**ADDENDUM NO. 2**

April 19th, 2016

2016 Delaware Elementary School Roof Replacement

Morley and Associates, Inc.  
Architect's Project No. 9778**GENERAL:**

Designed By: CME	Job Number: 9778.1.001
Drawn By: CME	Date: 04/19/2016
Filename: 9778.1.001	Sheet Number: AE101

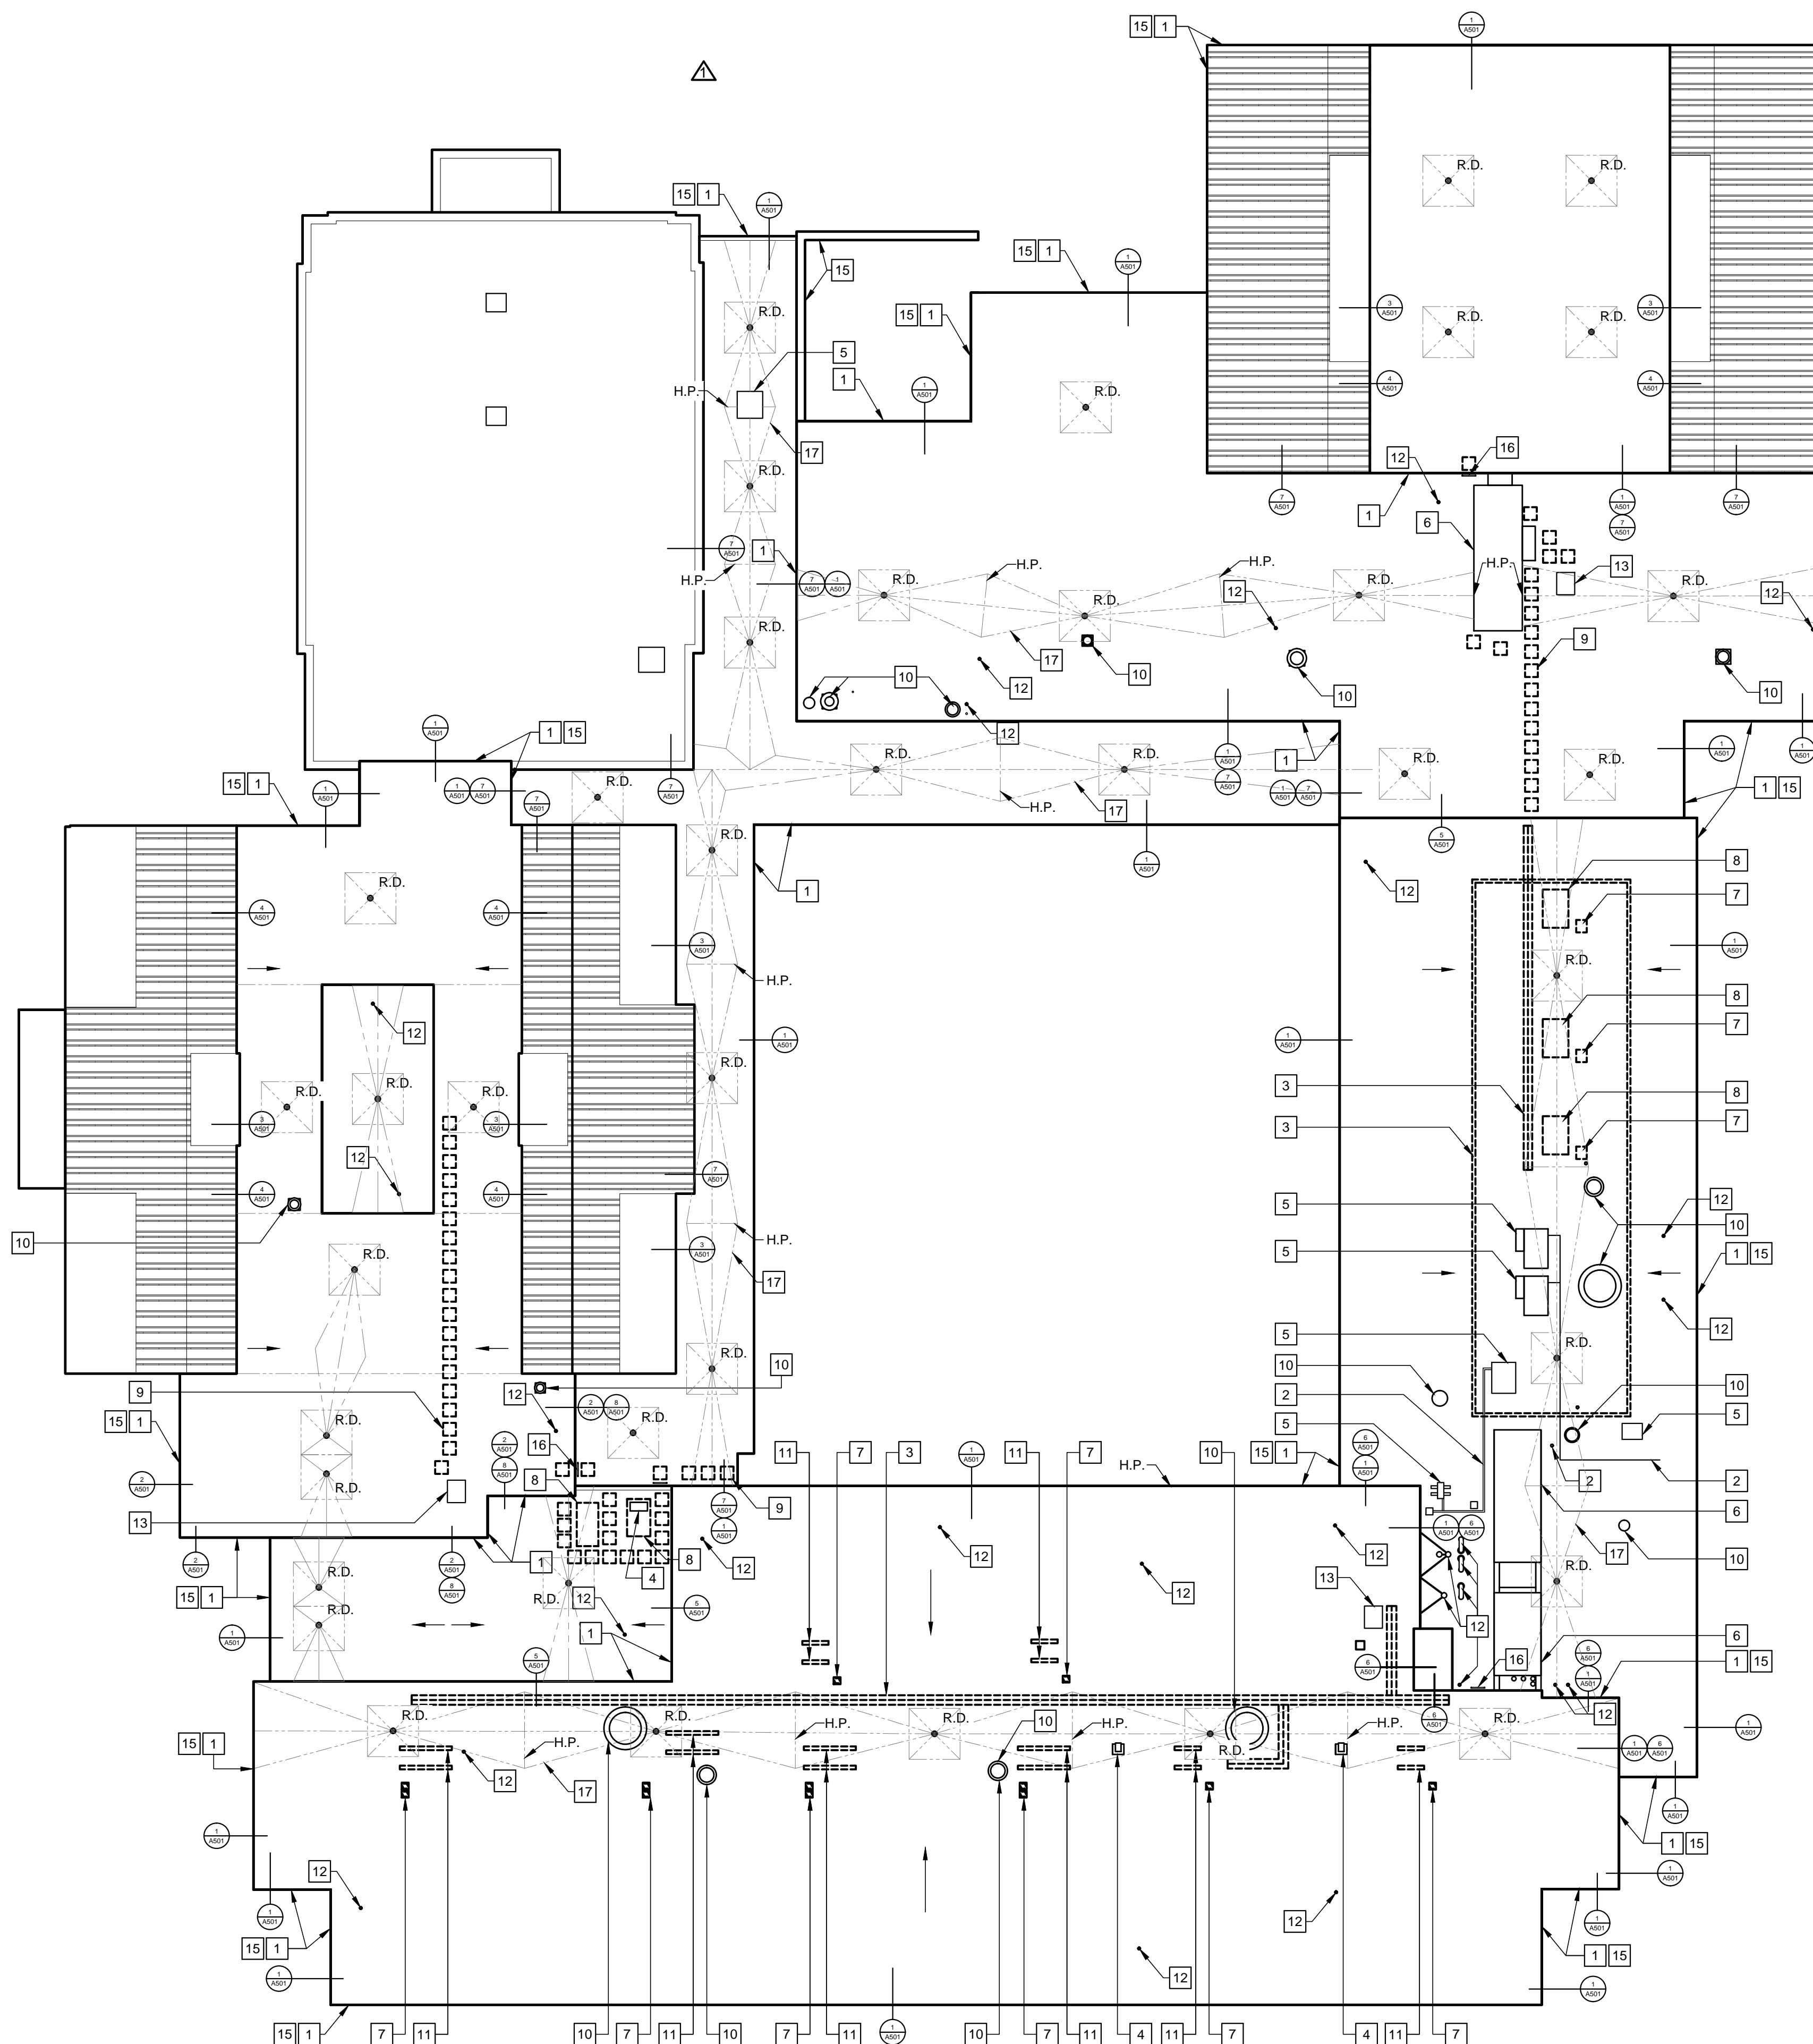
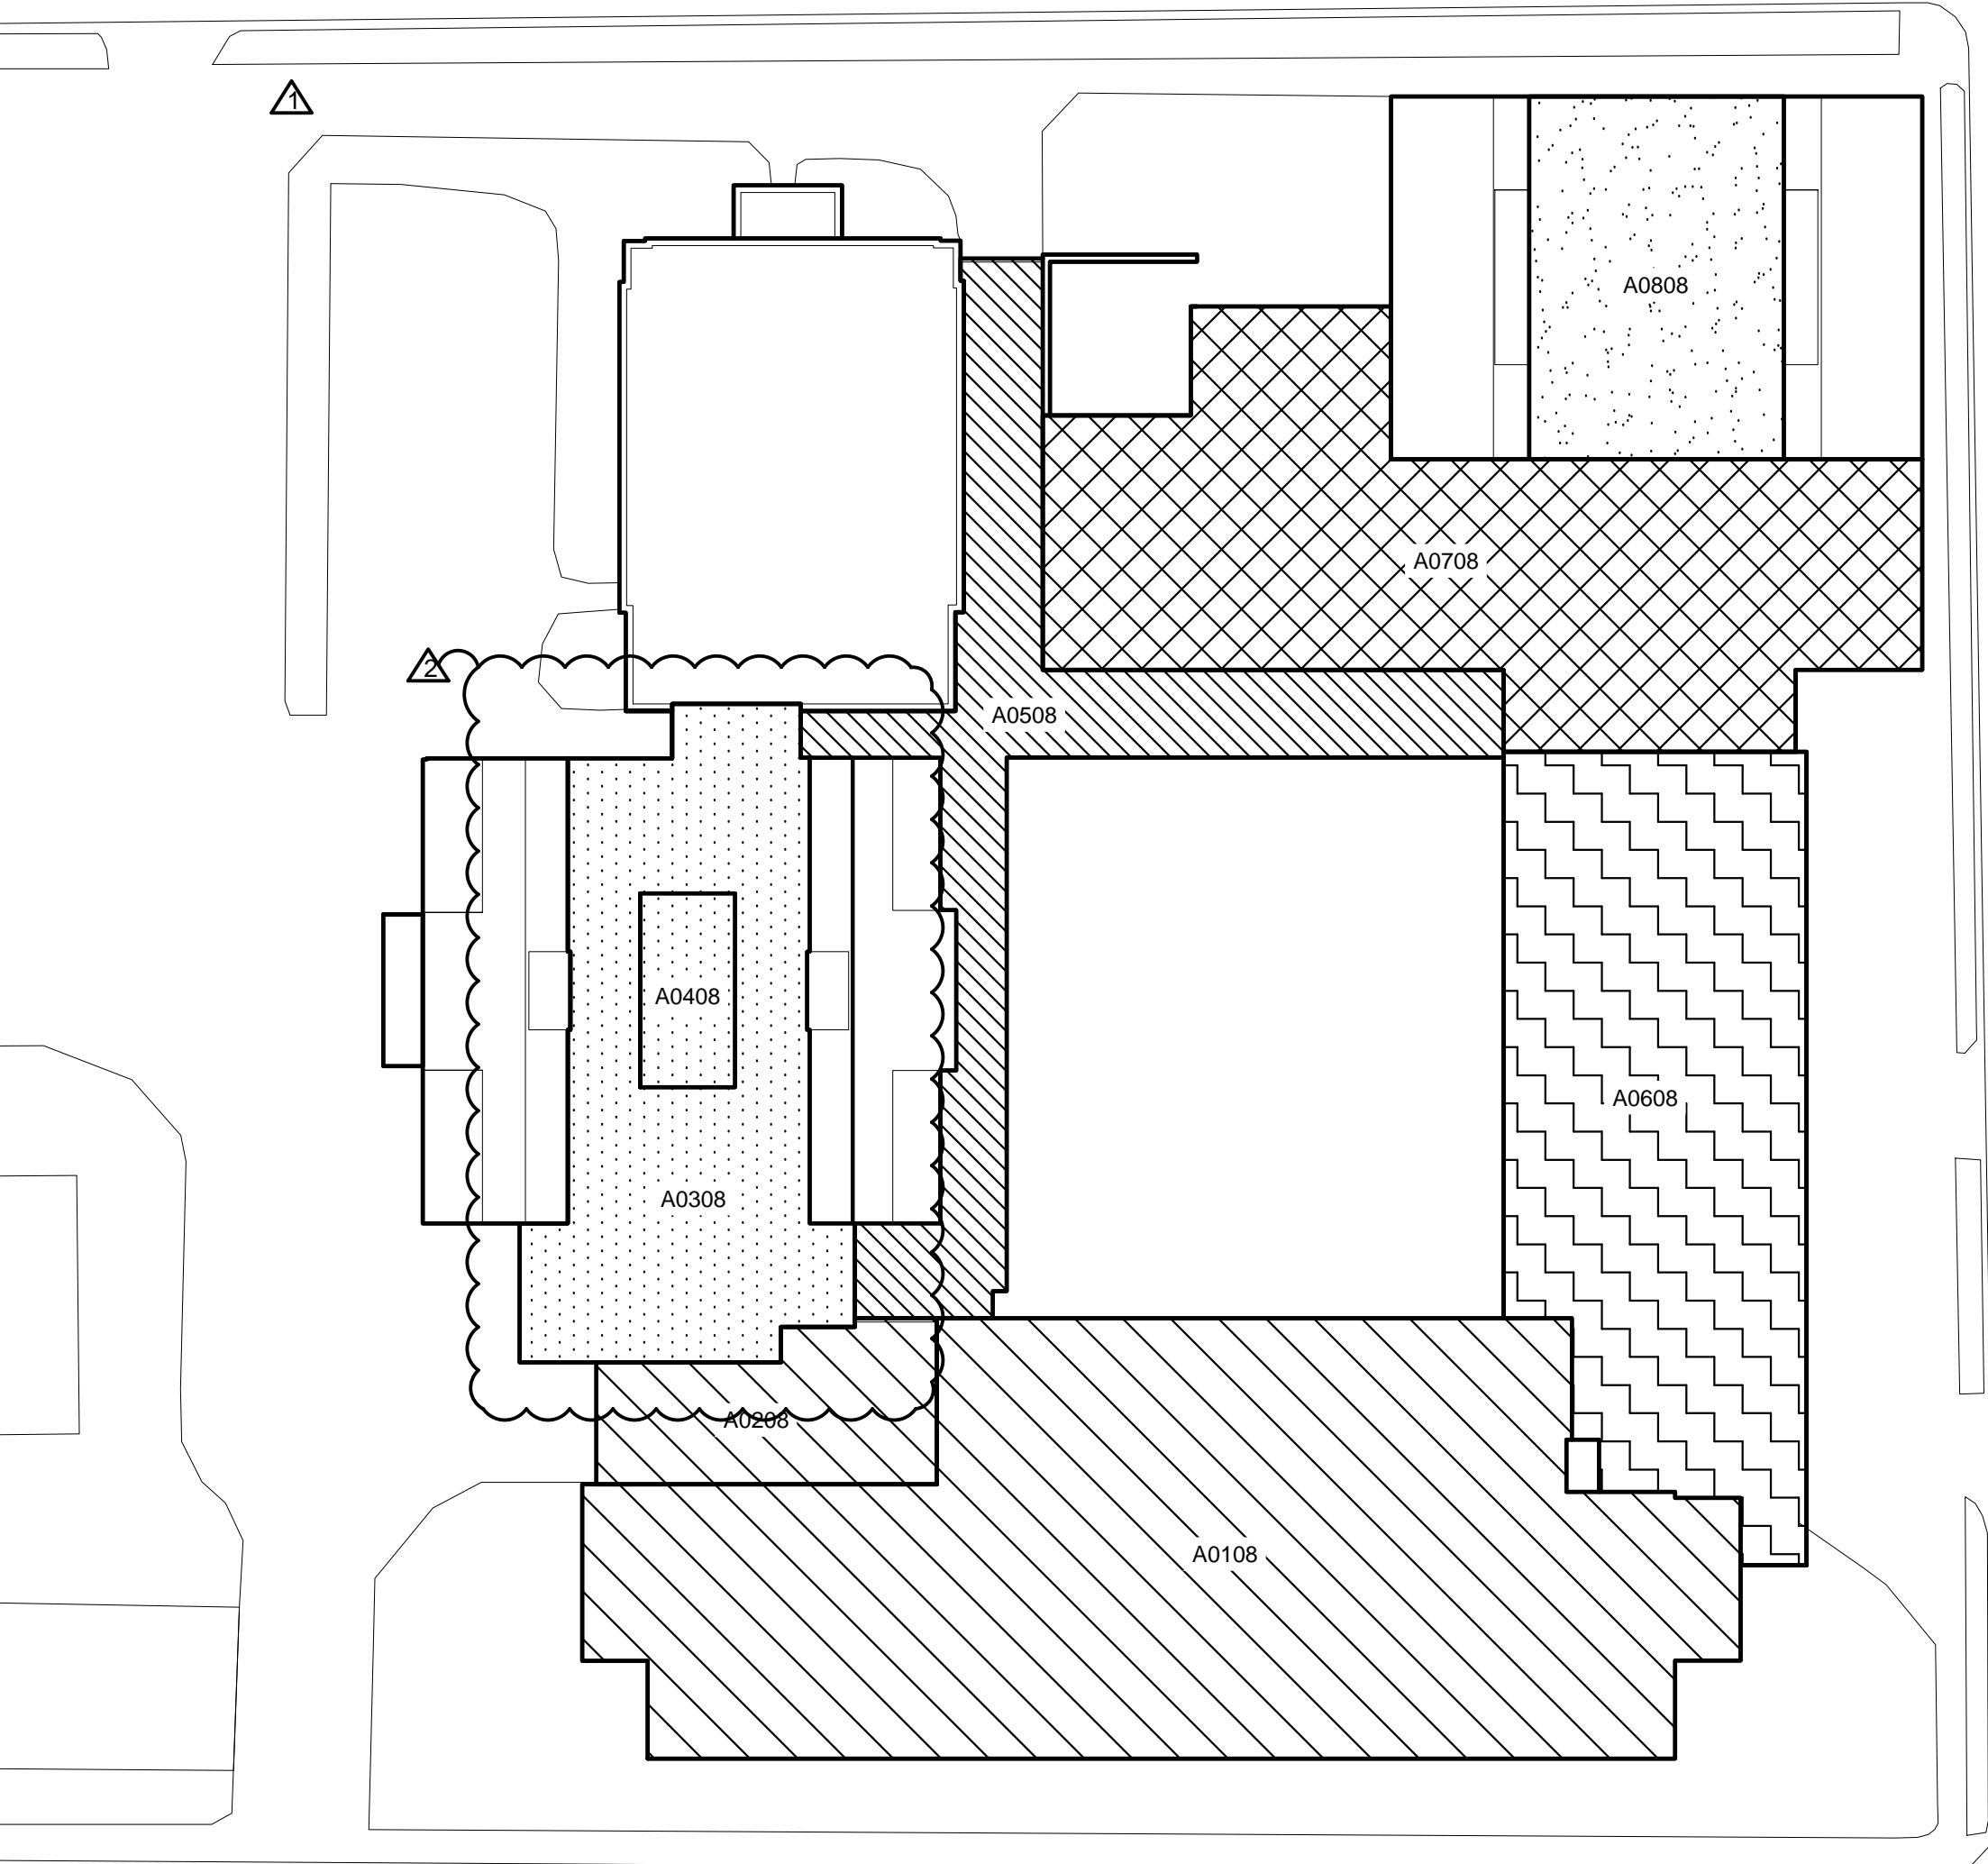
- 2-07 **Architectural:** Clarification of phasing schedule.  
A. See Roof Phasing Plan on Sheet AE101 for hatching clarification.  
B. Phasing has been adjusted. Phase 4 per bid and addendum 01 has been moved to Phase 01 with all phases subsequently shifting back except phases 5 and 6 which are to remain in order.
